2424 Briarcrest - DIR-2022-9281-DRB-SPP-HCA. ENV-2022-9282-CE
BABCNC PLU

Clarifications and answers in response to 02-21-2023 BABCNC PLU meeting

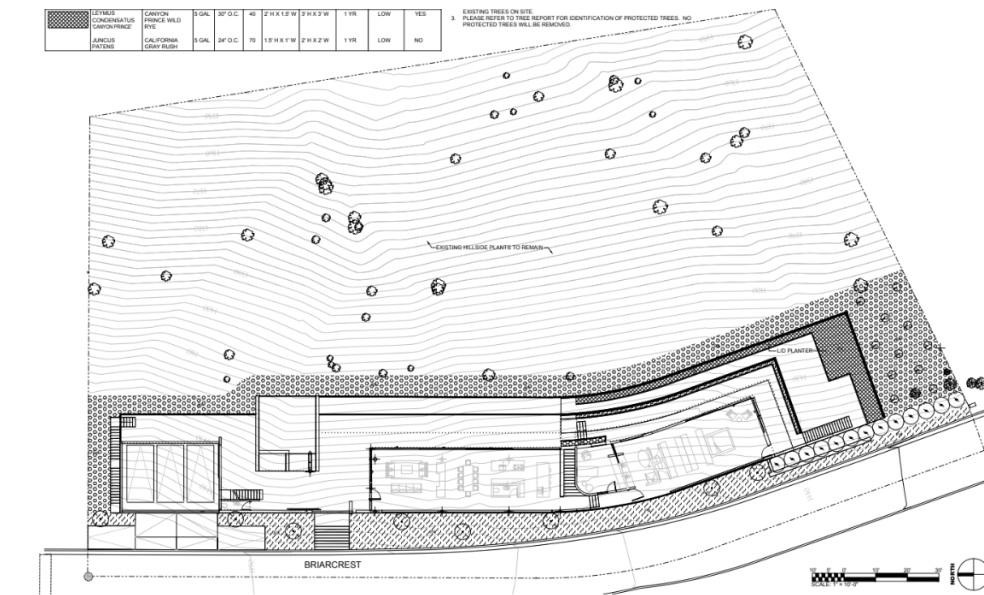
- b. Added questions on the environmental report section for natural resources protection plan and the biologist conclusion. And the mountain lion analysis section of the report and the conclusion drawn regarding deer frequenting property (ie: SMMC mapping).**

This section of the Biological Report has been modified. You can find it in the new Report in the submitted documents we have attached.

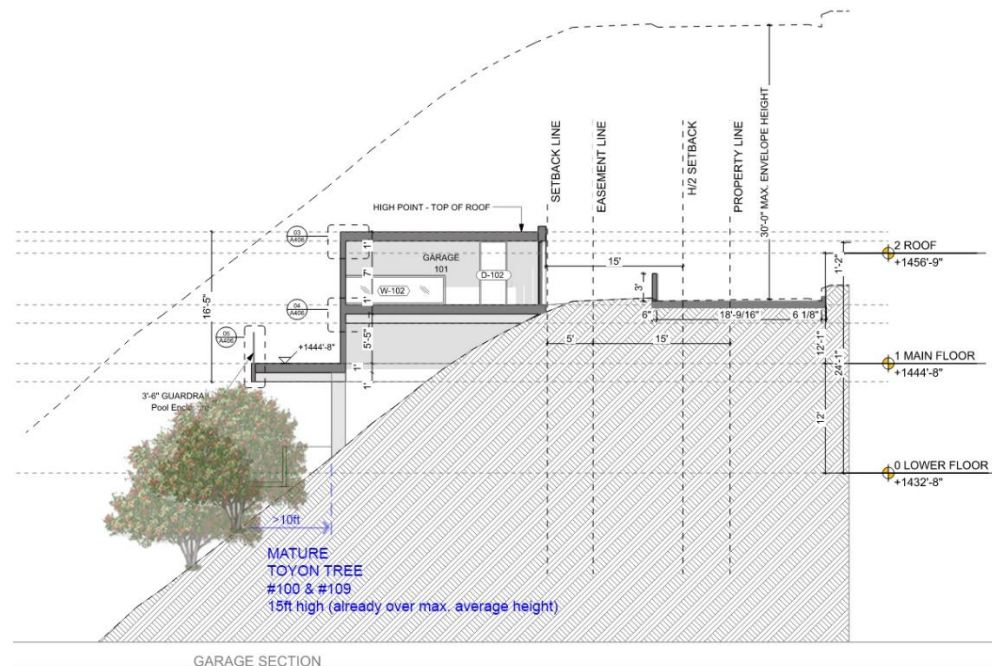
- b. Questions regarding errors in the environmental report on tree species for both California Walnuts and Toyons. If report is corrected on the species, then do sensitive natural communities occur? Are any trees in need of mitigated that are not reported due to encroachments (near construction).**

In relation to the errors made in the Tree Report, the arborist agreed with it and modified the names as suggested by Travis Longcore. For example, in the list, number 33, the name of the tree was correctly replaced by Southern California Black Walnut. You can find the rest of the corrections in the complete Tree Inventory in the Tree Report.

This modifications on the trees names does not impact the trees classification. As explained in the Biological Report, the project contains three habitats onsite that are protected under the City’s SEA Program.
